Access Compliance Report Public Rights-of-Way (Curb Ramps)

Main Street: LORING_DR Cross Street: MONTECITO_RD Location: NW

ADA ID: RPRK211210135403 Ramp Type: Blended Transition 1 Initial Pass/Fail: Fail Overall Compliance: No Severity Score: 30

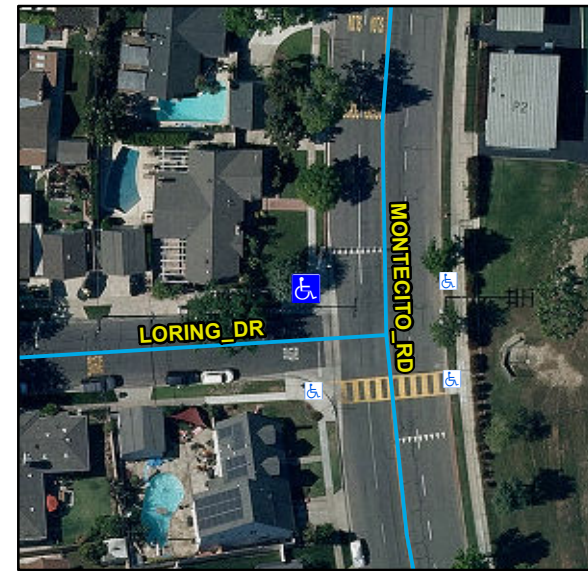
Compliance	Description	Data	Compliance	Description	Data
N/A	Ramp Length (in)	62	N/A	Flare Slope LT (%)	N/A
Yes	Ramp Width (in)	48	N/A	Flare Traversable LT	N/A
Yes	Ramp Run Slope (%)	1	N/A	Flare Slope RT (%)	N/A
No	Ramp Cross Slope (%)	9.3	N/A	Flare Traversable RT	N/A
N/A	Landing Present	N/A	N/A	DWS Provided	N/A
N/A	Landing Length (in)	N/A	N/A	DWS Contrast	N/A
N/A	Landing Width (in)	N/A	N/A	DWS Length (in)	N/A
N/A	Landing Run Slope (%)	N/A	N/A	DWS Full Width	N/A
N/A	Landing Cross Slope (%)	N/A		DWS Offset Type	N/A
N/A	Landing Movement Obstructed?	N/A	N/A	DWS Offset Left (in)	N/A
	Landing Movement Type	N/A	N/A	DWS Offset Right (in)	N/A
N/A	Landing Shared	N/A			
N/A	Clear Space	Yes			
N/A	Clear Space To Crosswalk (in)	N/A			
N/A	Marked Crosswalk 1	No	N/A	Marked Crosswalk 2	No
	Crossing 1 Direction	S		Crossing 2 Direction	E
	Marked Crosswalk 1 Width (in)	N/A		Marked Crosswalk 2 Width (in)	N/A
N/A	Ramp Inside Crosswalk 1	N/A	N/A	Ramp Inside Crosswalk 2	N/A

Remove & Replace Curb Ramp With Two New Directional Ramps or Equivalent.
